MODEL: GP605 / 555 / 605P

SUBJECT: Prevention of Faint Copies

Figure 1

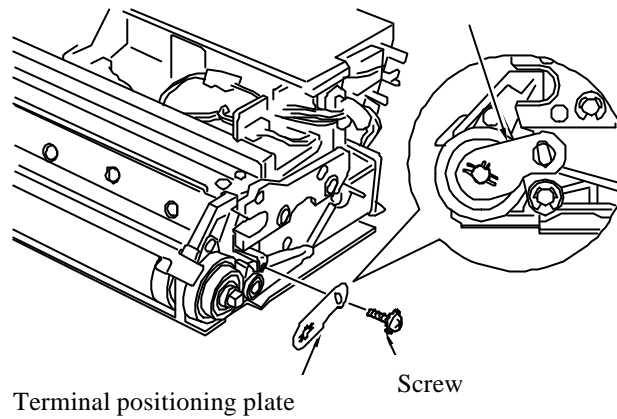
1. Remove the magnet positioning plate by first removing the retaining screw at the front side of the developing assembly.

Figure 2

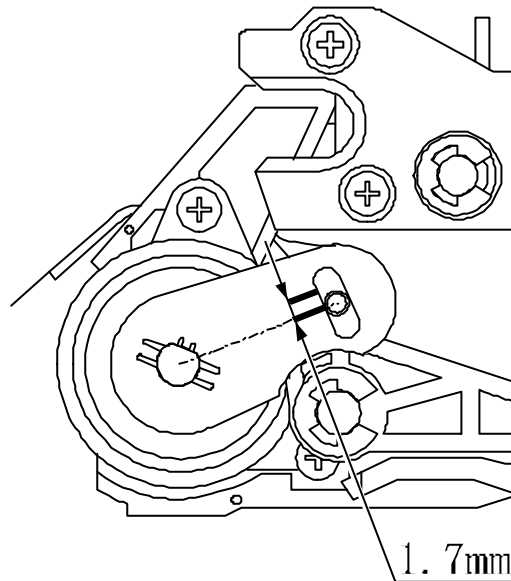
2. Mount the magnet positioning plate, as fitted, on the sleeve shaft.
3. While the magnet positioning plate stays without displacement as it is, draw a line as a guide on an assumed straight line connected between the center point of the sleeve and the screw.

Figure 3

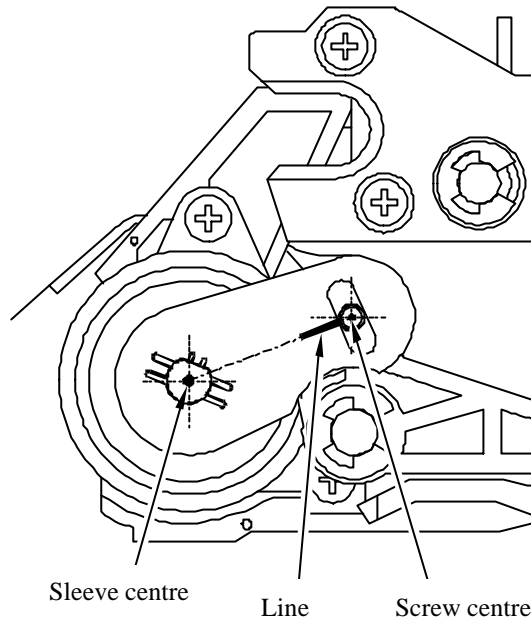
4. Draw a parallel line at 1.7mm above from the line drawn in Step 3.

Figure 4

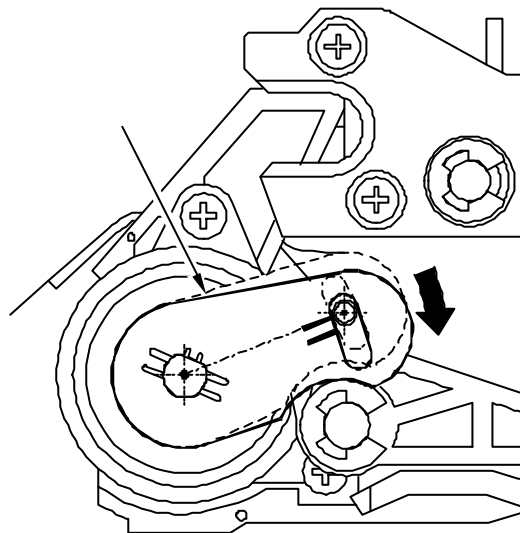
5. Turn the magnet positioning plate round clockwise with fingers until the line drawn in Step 4 comes to the screw centre. (Shift the magnetic pole by 5 degrees.)

Figure 5

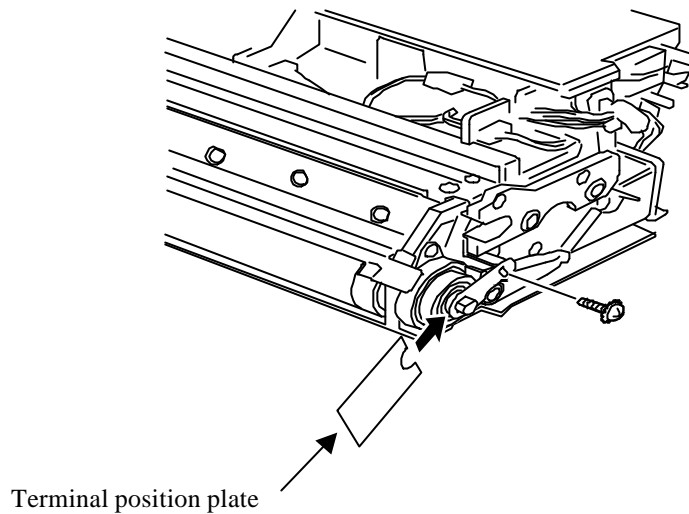
6. Tighten the screw for preventing the position set in Step 5 from shifting.
7. When the magnet positioning plate is mounted, put approx. a-0.2-mm width spacer under the plate. Once the plate is successfully mounted, remove the spacer.
